Released Engineering Change Notice

Product	iLive Consoles
Title	USB skts added to Front Connector, plus new USB leads
Date	20TH FEBRUARY 2008

Reason for change
To assist production assembly

003-540 PNL ASSY ILIVE BASE

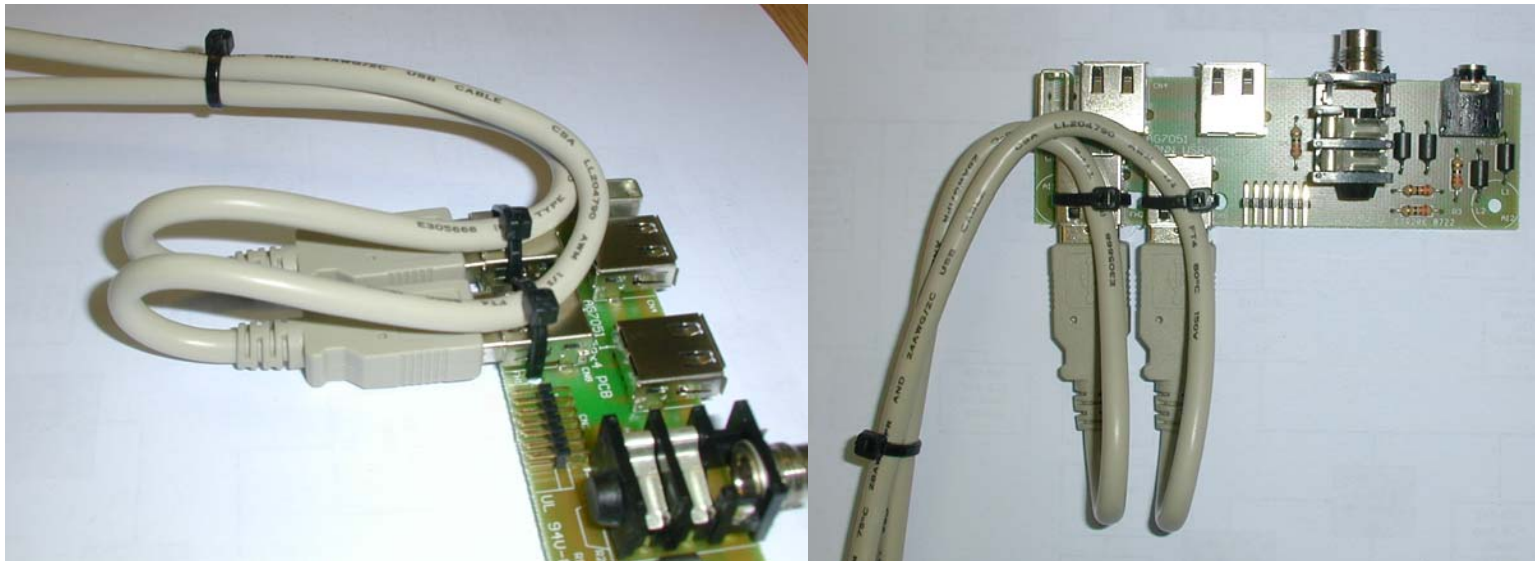
Replace existing cut and hard wired AH7060 USB Cable into 003-747 Front Connector, with x2 new AH7277 USB Cables. Secure with x3 Cable ties. Ensure radius of folded wires not too tight. See photos attached.

Secured using cable ties to limit risk of USB connectors falling out.
